SUBMISSION OF PROPOSED DRAWING CHANGES

10 INTERNATIONAL APPLICATION NO.: PCT/EP99/08074

INVENTION: "SURFACE ACOUSTIC WAVE ARRANGEMENT WITH
AT LEAST TWO SURFACE ACOUSTIC WAVE
STRUCTURES"

~~FIG 4~~

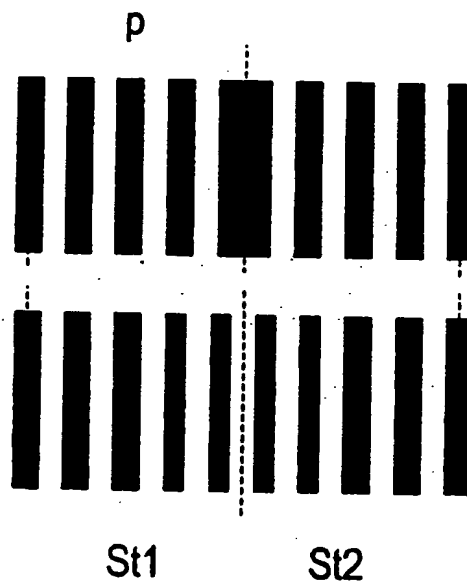
20 Applicants propose to correct Fig. 4 as indicated in red in the attached sheet
of drawings. If these corrections are approved, Formal Drawings incorporating the
change to Fig. 4 will be submitted once the application has been allowed.

FIG 4 a)

FIG 4 b)
